**Kittitas County**  
**Teaway Solar Reserve**

**Public Comments**  
**After April 5, 2010 – August 3, 2010**

Comments from Doug Howie (WA Dept of Ecology) on Teanaway Solar Reserve Hydrologic Analysis Kittitas County, Washington, June 2010, prepared by CH2M-Hill.

Subject: Response to Department of Ecology Comments Provided on the Additional Submittal Materials Teanaway Solar Project Hydrologic Analysis

**FIGURE 3**  
**Proposed Site Layout with**  
**Drainage Basins**  
 Hydraulic Analysis  
 Teanaway Solar Reserve  
 Kittitas County, Washington

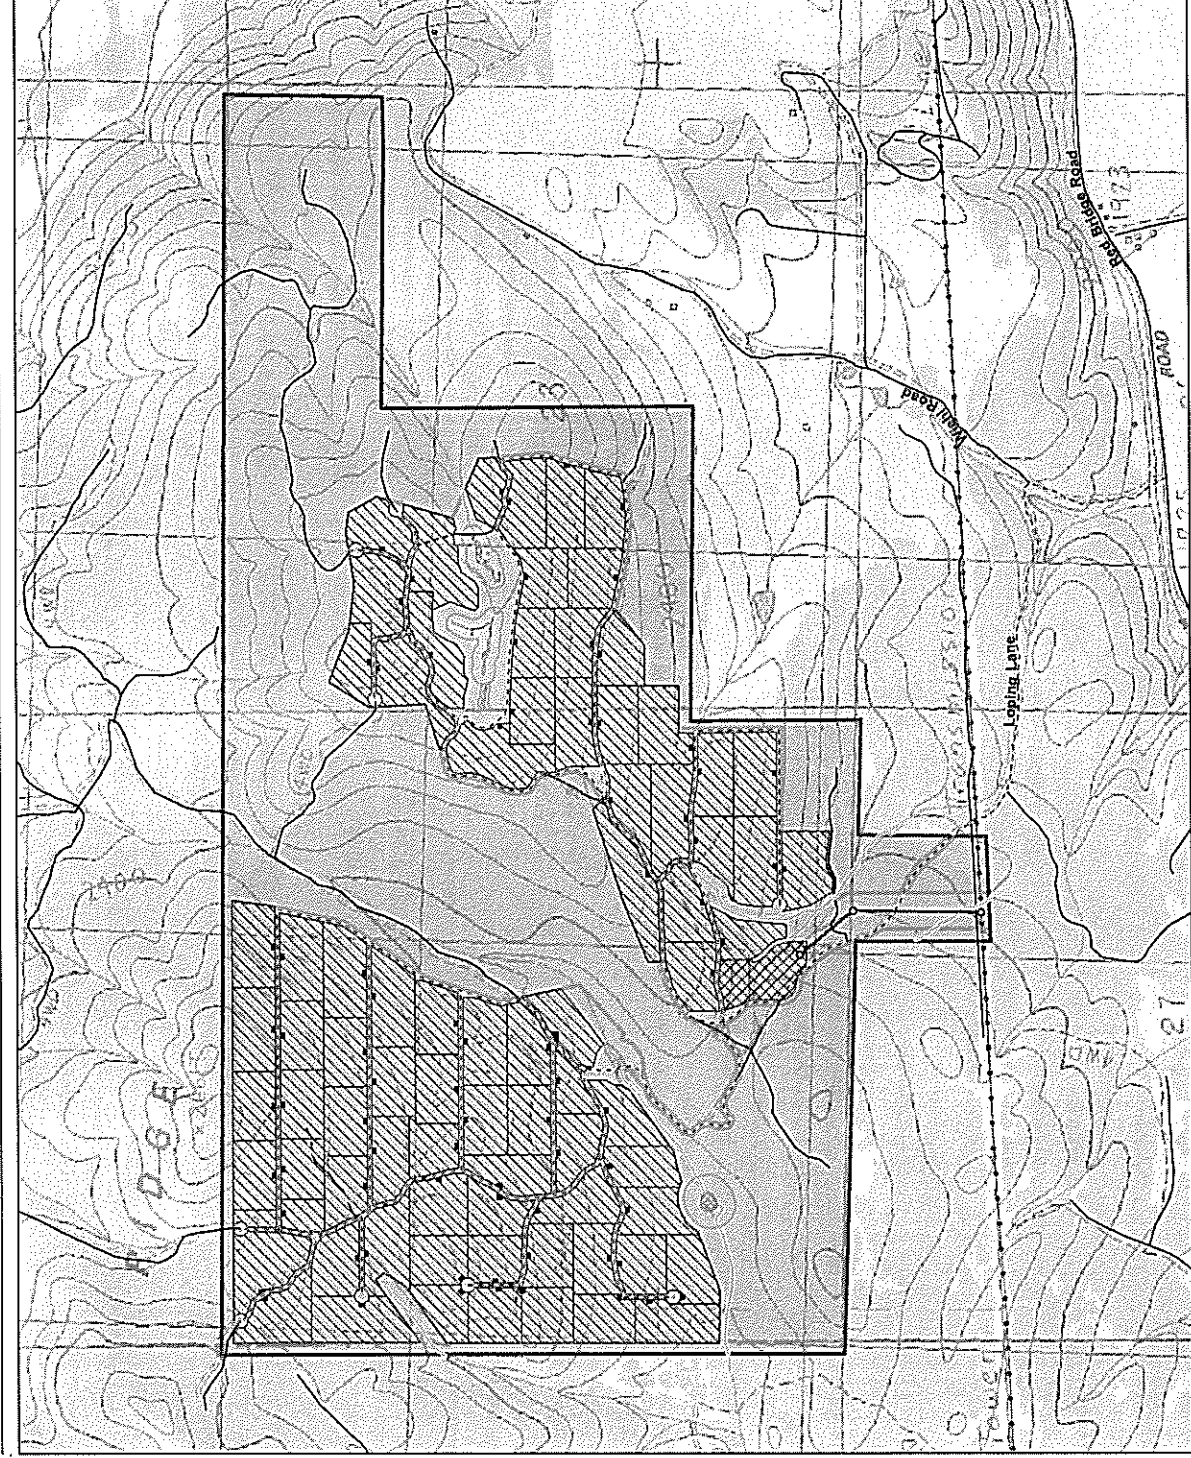
2. Please show the two basin boundaries on the Figure that shows the project boundary. It is difficult to see what part of drainage basin is the project site and what part is outside the project site.

*The proposed project site is defined at 477 acres, and the project area is 982 acres. The North drainage basin encompasses 259 acres, of the project area and the South drainage basin encompasses the remaining 723 acres. The basins within the project area are illustrated in purple and blue on Figure 3 (see attached).*
